UNITED STATES PATENT AND TRADEMARK OFFICE

| Office Action Summary | Application No. 10/720,563 | Applicant(s) MATSUURA ET AL. | |

Title: COIL BOBBIN STRUCTURE
Inventors: Matsumi MATSUURA and Genta YOSHII
Serial No.: 10/720,563— Filed: November 24, 2003
Schulte Roth & Zabel, LLP — John J. Skinner, Jr.
Atty. Ref.: 051319/0077

FIG. 6
PRIOR ART

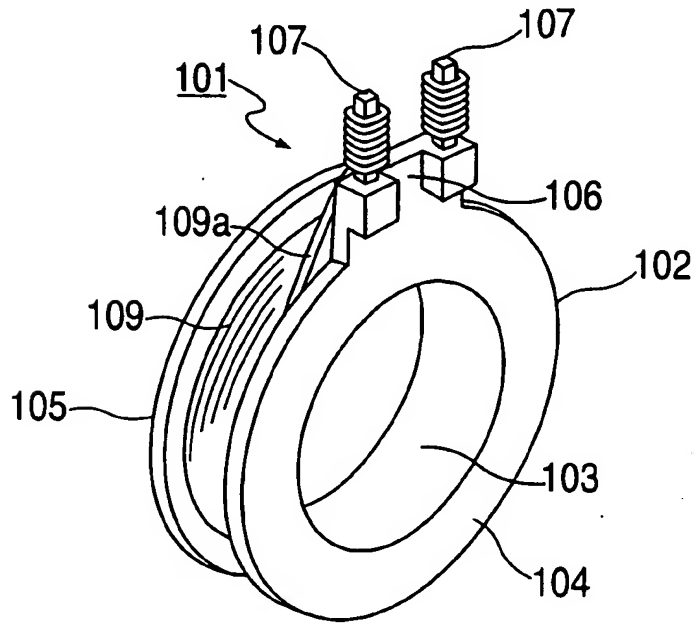
Claims 1-3 are rejected under 35 U.S.C. 102(b) as being anticipated by Applicant's Prior Art figures 6-8.

The prior art figures disclose a bobbin main body having flanges (104, 105) at both ends in the axial direction of a cylindrical winding drum portion; two terminal supports (the two protrusions at 106 in Fig. 6 and 206 in Figs. 7 and 8), at a portion of one of the flanges protruding in the outer direction of the diameter direction, with a gap (gap between the supports) between the two terminal supports, the terminal supports being provided with two terminal pins 107 that are standing; a wire (109, 209) that is wound around the outer circumference of the winding drum portion of the bobbin main body, each end of which are respectively wound and fixed to the terminal pins; a coil bobbin structure in that the two terminal supports are installed and the terminal pins are provided respectively to each terminal support so as to be standing; and a guide groove (groove or step under each terminal support) is provided respectively to each terminal support, and wherein each extremity of the wire passes from the winding drum portion through the gap between both terminal supports (as in Fig. 7), is wound into each terminal support, passed through the guide groove, is guided to the terminal pin and is wound and fixed to the terminal pin.

In reply to the remarks bridging pages 6 to 7 regarding the two terminal supports, Prior Art figure 6, for example, clearly shows a support for each pin. Nothing in the language of the claims precludes a unitary structure.
